# Access Compliance Report

## Public Rights-of-Way

Intersection ID: 24499	Main Street: BECKMORE_PL	Cross Street: SAINTFIELD_PL	Location: SE
ADA ID: 2FA3B118CC3B	Ramp Type: Perp	Initial Pass/Fail: Fail	Overall Compliance: No
Severity Score: 25			
Codes/Mitigation Info/Possible Solution		Field Measurements/Component Compliance

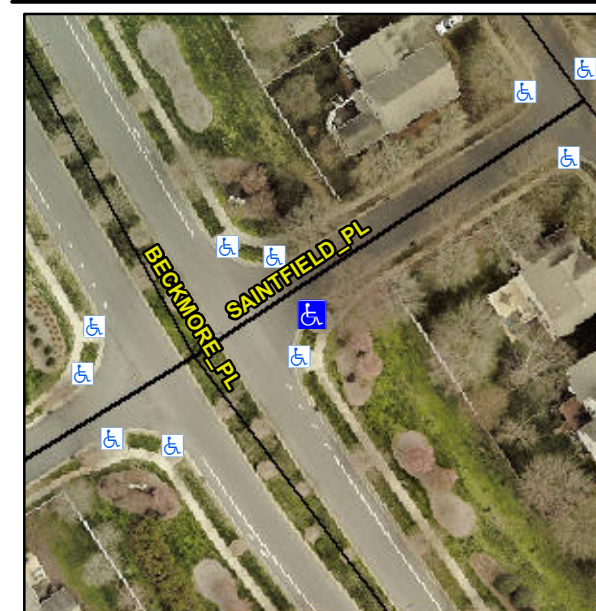
**Not Found, R304.2.2, R304.5.3**

Compliance	Description	Data	Compliance	Description	Data
N/A	Ramp Length (in)	93.0	No	Ramp Slope (%)	8.7
Yes	Ramp Width (in)	75.0	No	Ramp XSlope (%)	6.4
N/A	Flare Type LT	N/A	N/A	Flare Type RT	N/A
N/A	Flare Slope LT (%)	N/A	N/A	Flare Slope RT (%)	N/A
N/A	Flare Traversable LT?	N/A	N/A	Flare Traversable RT?	N/A
N/A	Landing Length (in)	N/A	N/A	DWS Provided?	N/A
N/A	Landing Width (in)	N/A	N/A	DWS Contrast?	N/A
N/A	Landing Slope (%)	N/A	N/A	DWS Length (in)	N/A
N/A	Landing X Slope (%)	N/A	N/A	DWS Full Width?	N/A
N/A	Landing Curb? (Y/N)	N/A	N/A	DWS Offset (in)	N/A
N/A	Shared Landing?	N/A			
N/A	Gutter Ponding?	N/A	N/A	Gutter Slope (%)	N/A
N/A	Gutter Lip Ht (in)	N/A	N/A	Gutter X Slope (%)	N/A
N/A	Painted X Walk1?	No	N/A	Painted X Walk2?	N/A
	X Walk 1 Direction	To N		X Walk 2 Direction	N/A
N/A	X Walk 1 Width (in)	N/A	N/A	X Walk 2 Width (in)	N/A
	X Walk 1 Slope (%)	0.9		X Walk 2 Slope (%)	N/A
	X Walk 1 X Slope (%)	4.7		X Walk 2 X Slope (%)	N/A

**Remove & Replace Entire Ramp.**
